This Service Information bulletin supersedes SI M17 08 12 dated **October 2012**.

Service Action: Retrofit of the Engine Coolant Temperature Sensor

This Service Action involves R55, R56, R57 and R58 MINI Cooper/Cooper S vehicles with the N16 or N18 engine which were produced from 8/2010 to 3/2012.

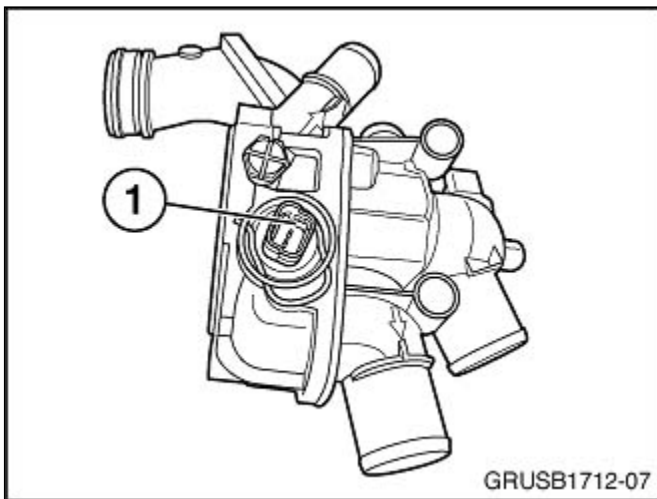
NEW There are two approved repair procedures, depending on parts availability. Both procedures involve installing an engine temperature sensor remotely and wiring this new sensor into the vehicle's engine harness. Only perform one of these recommended procedures when completing this Service Action.

NEW **Procedure One** requires the replacement of the upper coolant hose with a modified hose that houses a new engine temperature sensor. An adapter harness needs to be fitted to the car to utilize this new sensor.

NEW Procedure Two requires the installation of a new engine temperature sensor, with integrated wire harness, installed in place of the thermostat bleeder screw.
